Proposal for amendments to ECE/TRANS/WP.29/GRRF/2008/2 (Brake Assist Systems)

This document is a proposal for amendment to the Brake Assist proposal of document ECE/TRANS/WP.29/GRRF/2008/2 and concerns Brake Assist Systems of Category A with the evaluation of performance being made on the measurement of brake line pressure as an alternative to vehicle deceleration.

Regulation No. 13-H, Annex 10

Figure 1b

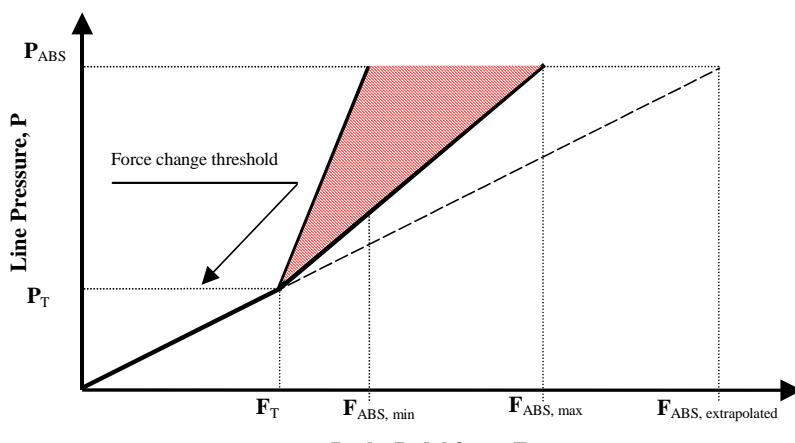
Add an additional paragraph 3.2.5. and amend the title of Figure 1 to read Figure 1a and add an additional Figure 1b.

“3.2.5. As an alternative, which can be selected by the manufacturer, the pedal force figures for F_T , $F_{ABS,min}$, $F_{ABS,max}$ and $F_{AB,extrapolated}$ may be derived from the brake line pressure response characteristic instead of the vehicle deceleration characteristic. This shall be measured as the brake pedal force is increasing.

- 3.2.5.1. The pressure, at which ABS cycling commences, shall be determined by making five tests from 80 km/h in which the brake pedal is applied up to the level which produces ABS operation and the five pressures at which this occurs as determined from front wheel pressure records, shall be recorded and the mean value obtained as P_{ABS} .
- 3.2.5.2. The threshold pressure P_T shall be stated by the manufacturer.
- 3.2.5.3. Figure 1b shall be constructed in the manner set out in paragraph 3.2.4. but using line pressure measurements to define the parameters set out in paragraph 3.2.5. above where:

$$F_{ABS,extrapolated} = \frac{F_T \times P_{ABS}}{P_T}$$
